Subject: **Modification Request for Nationwide Permit 14, Section 401 Water Quality Certification and Revised Application for a CAMA Major Development Permit** for the Proposed Replacement of Bridge No. 38 over Trent Creek on NC 55 in Pamlico County, North Carolina; TIP No. B-4593; Debit \$570 from WBS No. 42328.1.2

LOCATION: BRIDGE NO. 38 ON NC 55 OVER TRENT CREEK
TYPE OF WORK: GRADING, DRAINAGE, PAVING AND STRUCTURE.

PERMIT DRAWINGS
STREAM AND WETLAND IMPACTS

NC DEPARTMENT OF TRANSPORTATION
DIVISION OF HIGHWAYS
06/27/2019
PAMLICO COUNTY
B-4593
BRIDGE REPLACEMENT ON NC 55 OVER TRENT CREEK
SHEET 17 OF 17

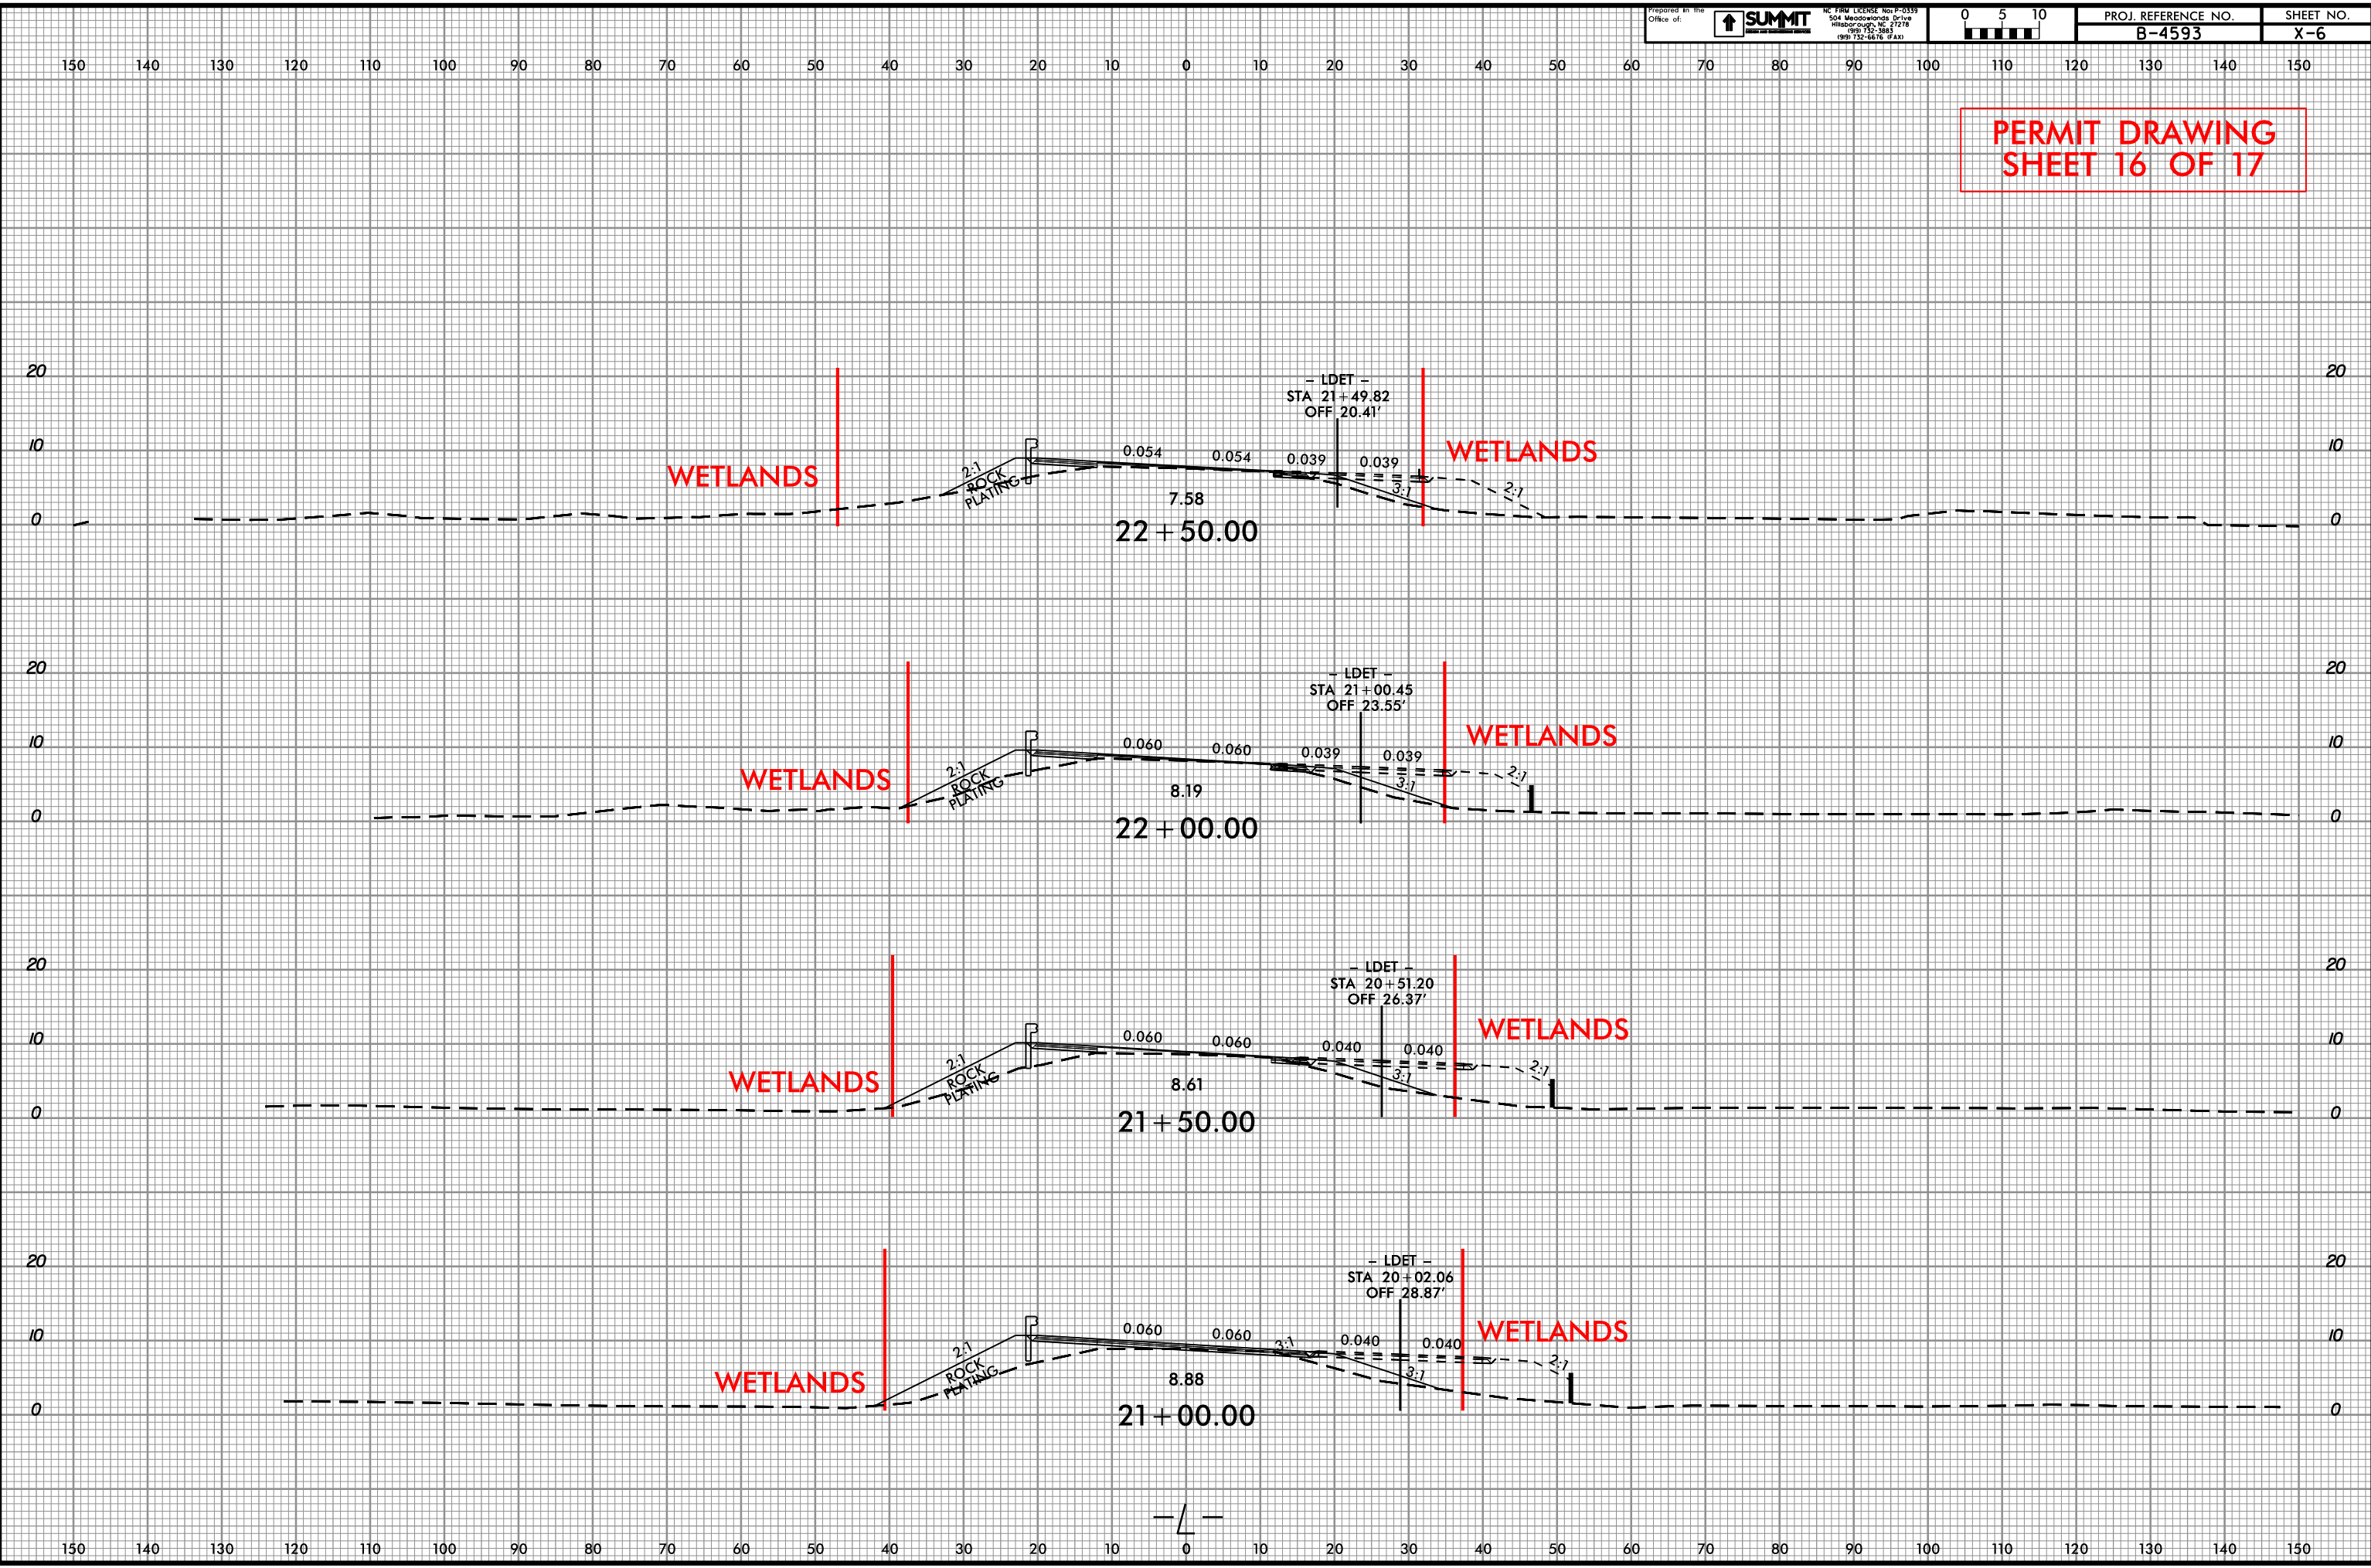
The summary sheet shows that 13 feet of temporary stream impacts have been added to account for the dewatering necessary to install rip rap. Temporary surface water impacts increased from 0 sq. ft. to 199 sq. ft., as listed in the notes. The notes also show the > 0.01 acre of permanent SW impacts more specifically as 143 sq. ft.

*Permanent SW impacts = 143 sf

**Temporary SW impacts = 199 sf

PERMIT DRAWING
SHEET 3 OF 5

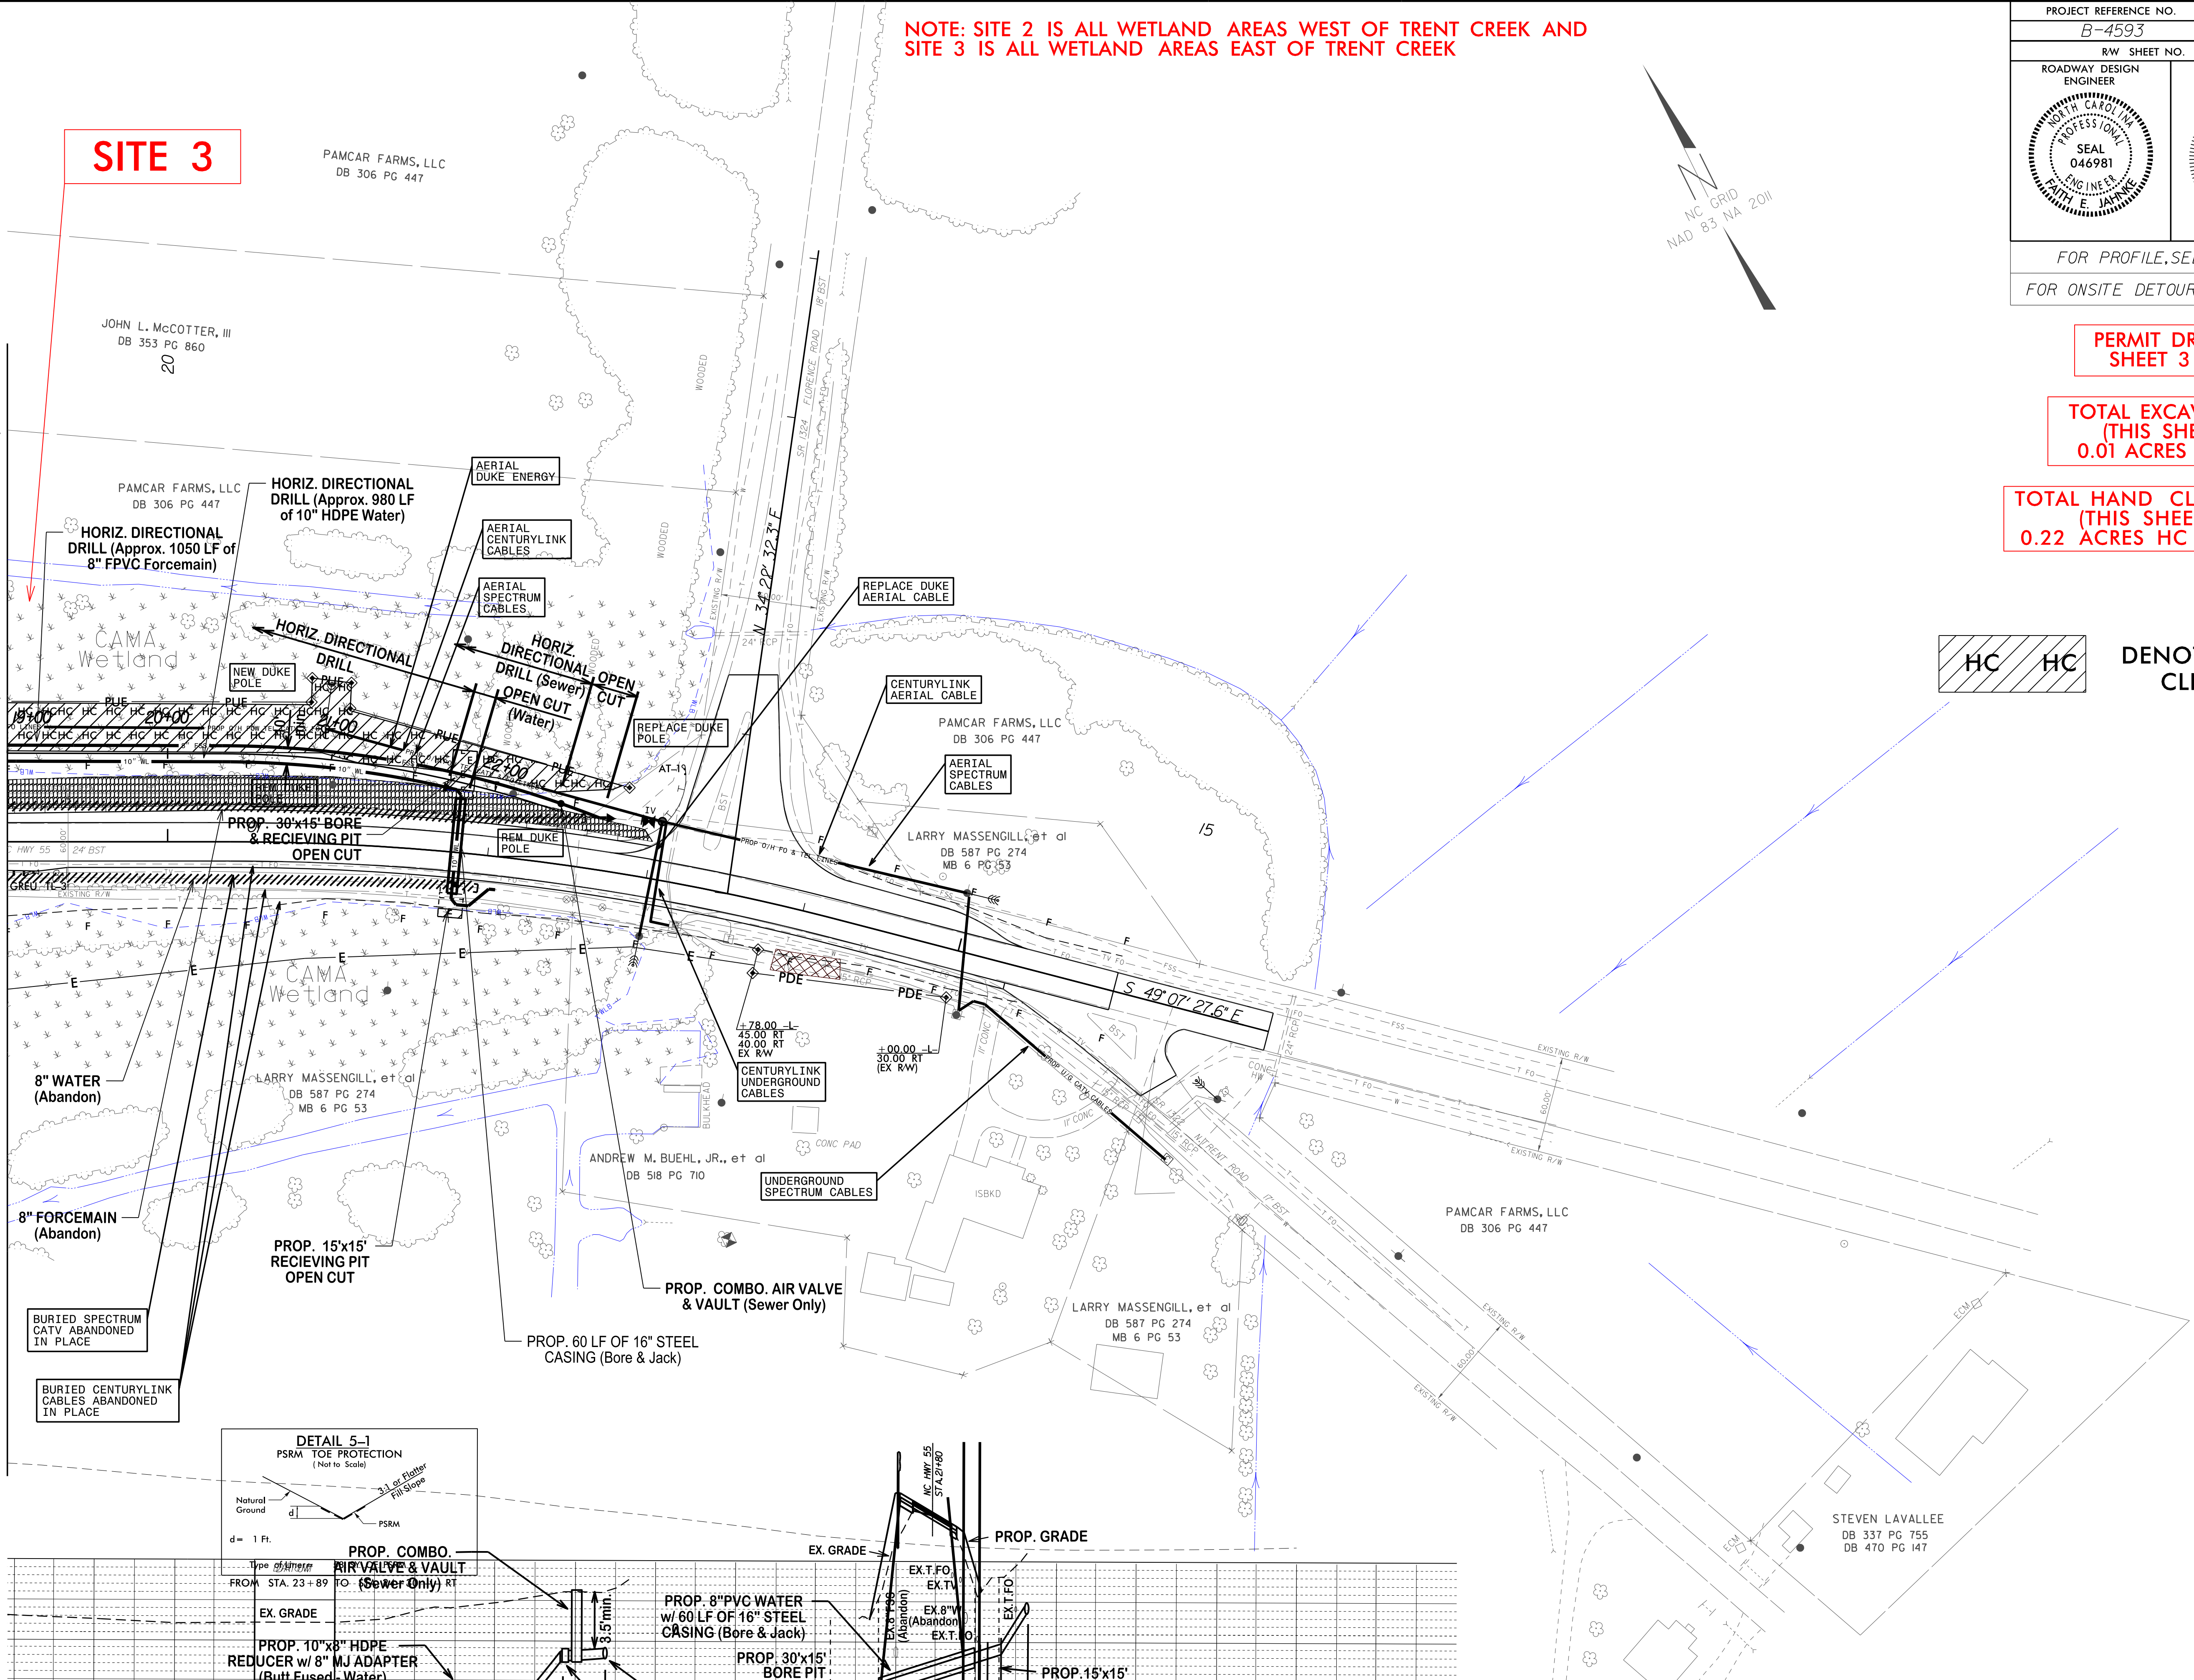
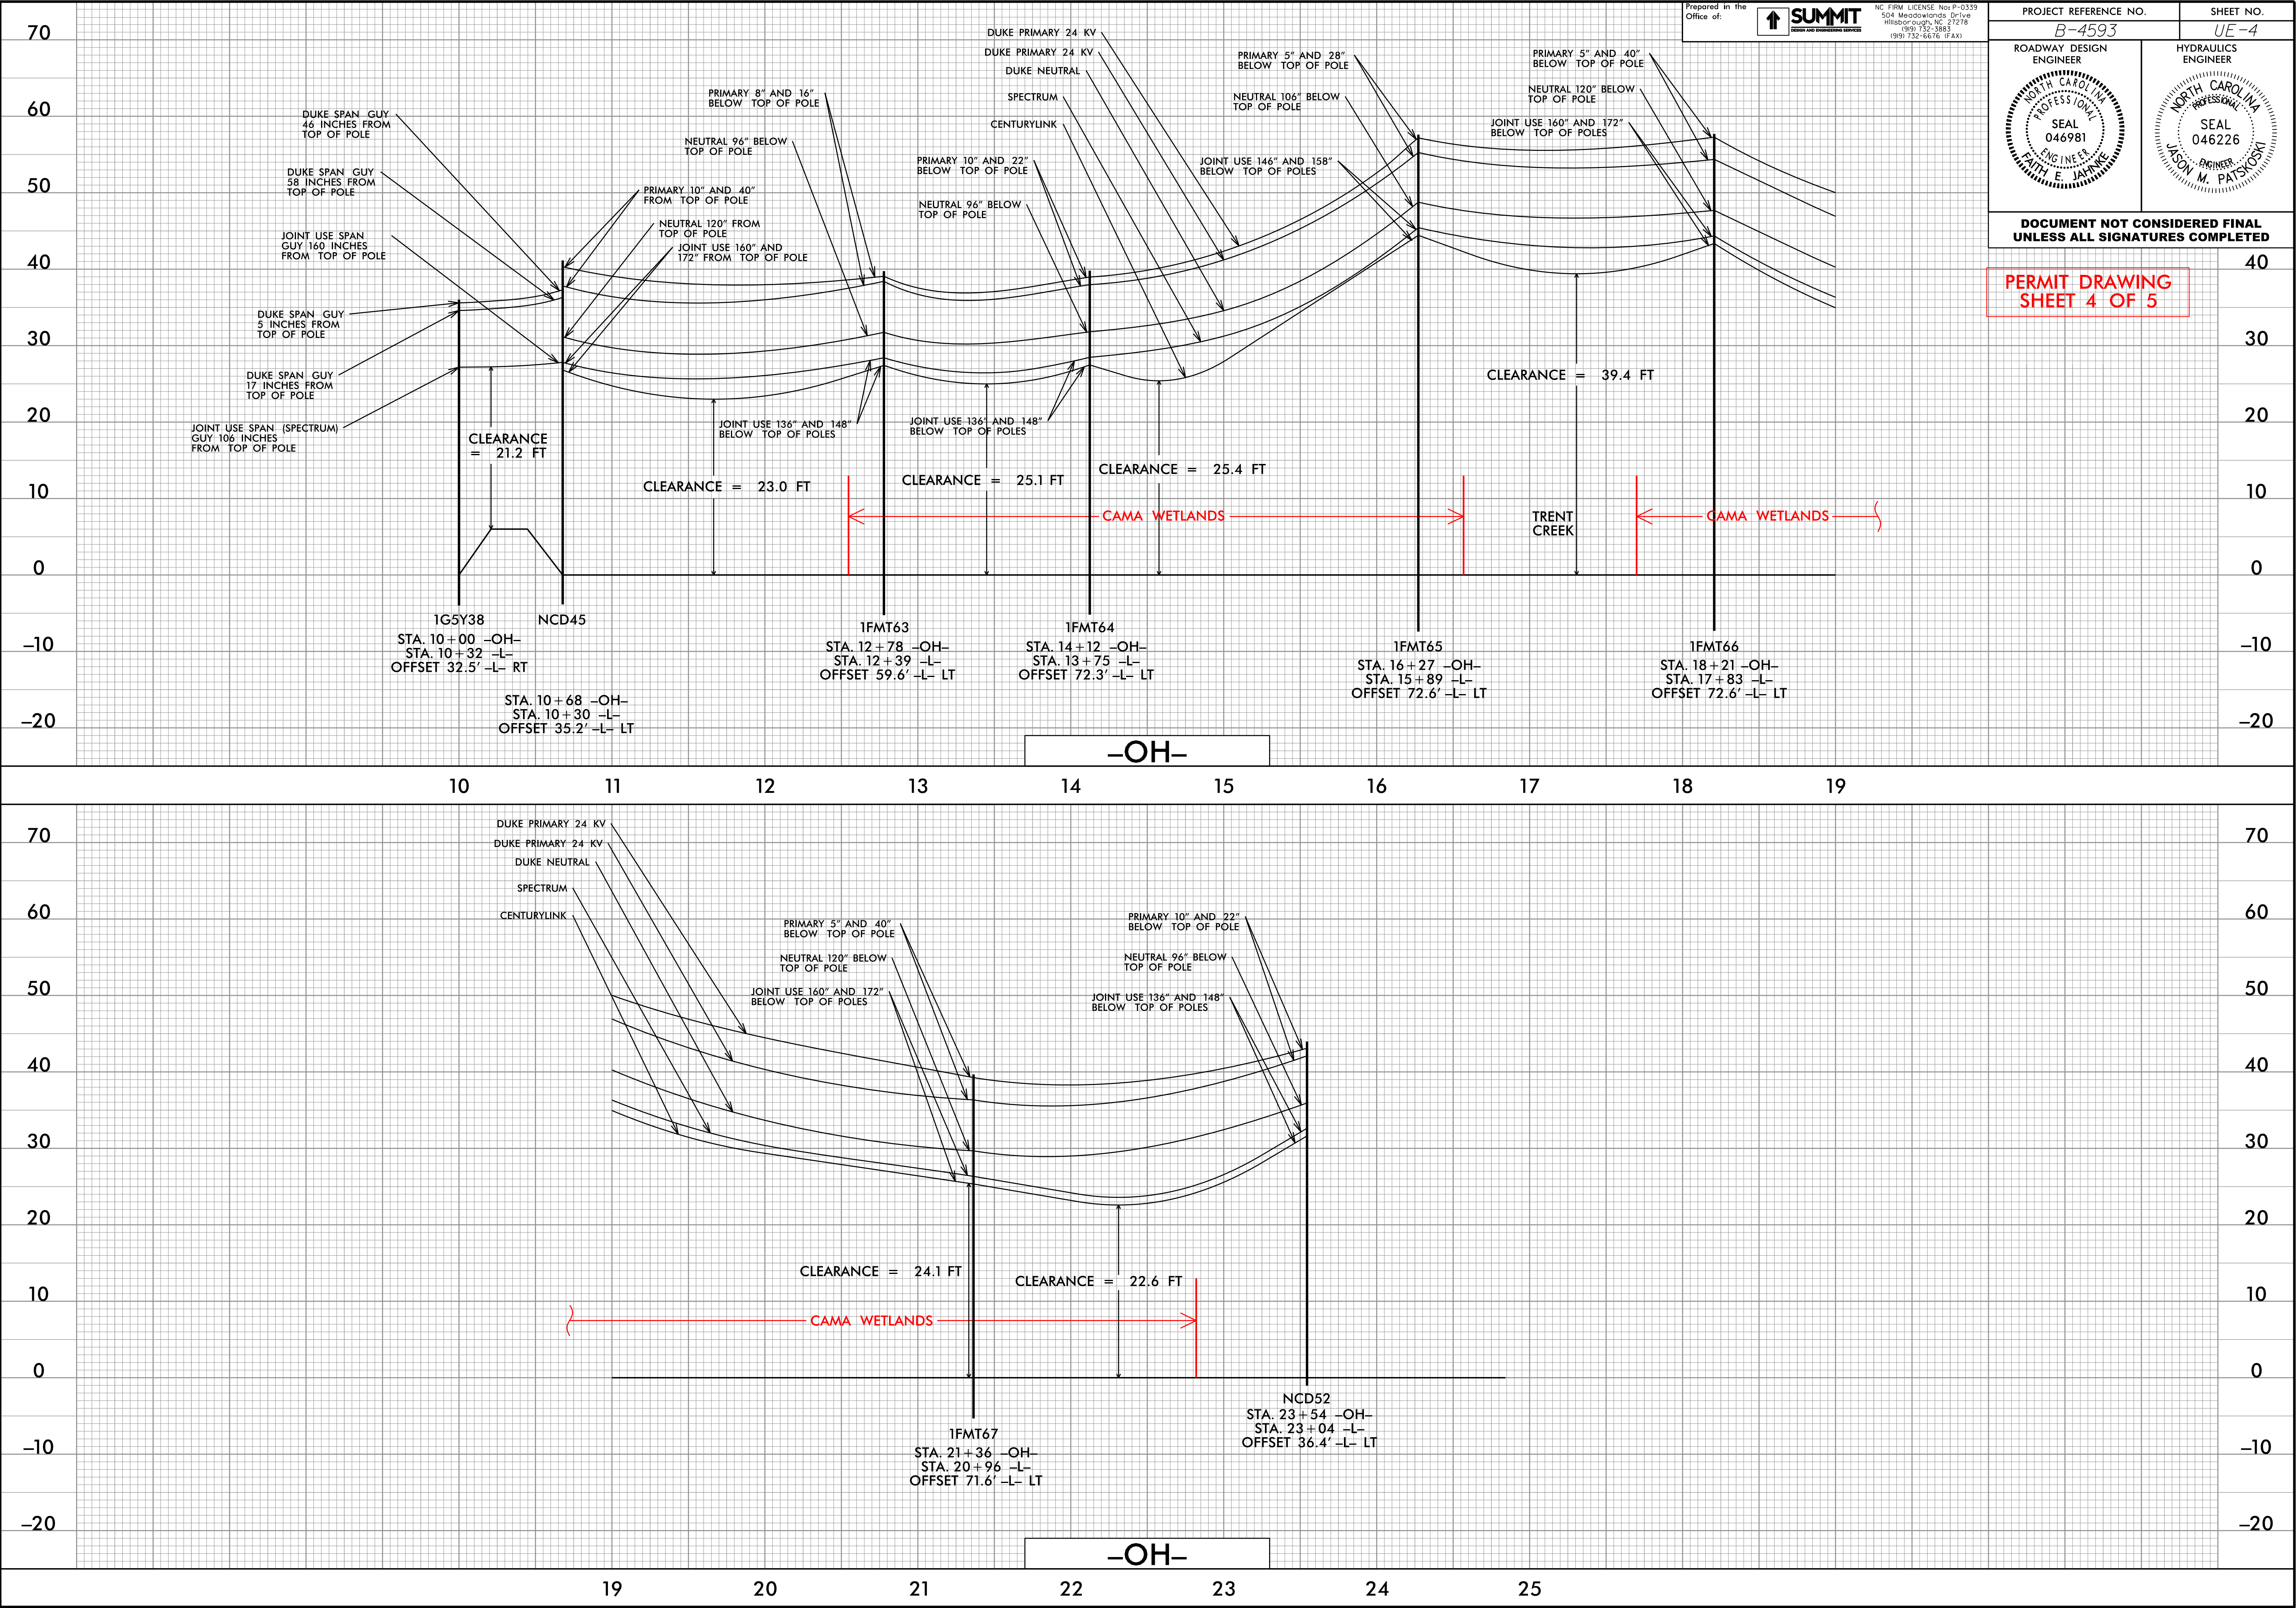
- Excavation/Hand Clearing limits revised for northwest waterline bore pit
- Excavation/Hand Clearing limits revised for northeast waterline bore pit
- Excavation/Hand Clearing limits revised for sanitary sewer open cut
- Excavation added for the southeast waterline receive pit which is within the wetland boundary
- Excavation Summary on UE-3 revised

TOTAL EXCAVATION
(THIS SHEET):
0.01 ACRES SITE 3
